Historic Preservation Commission

November 18, 2021

Certificate of Appropriateness

**328 14th Street SE – siding, soffit,
fascia**

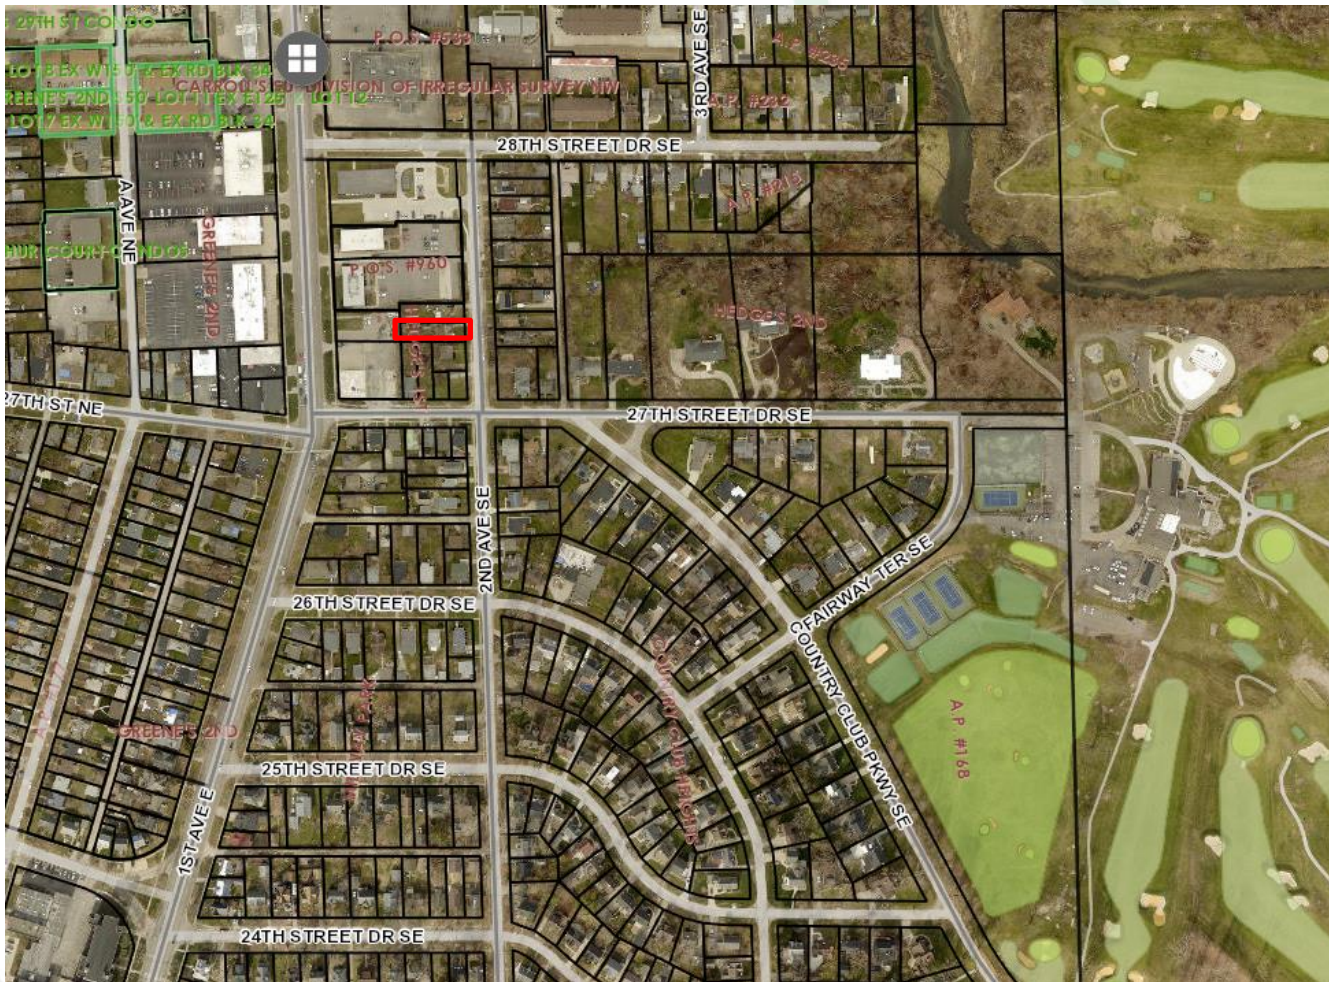
- Staff recommends denying the Certificate of Appropriateness for the proposed improvements as they do not comply with the Historic Preservation Design Guidelines.
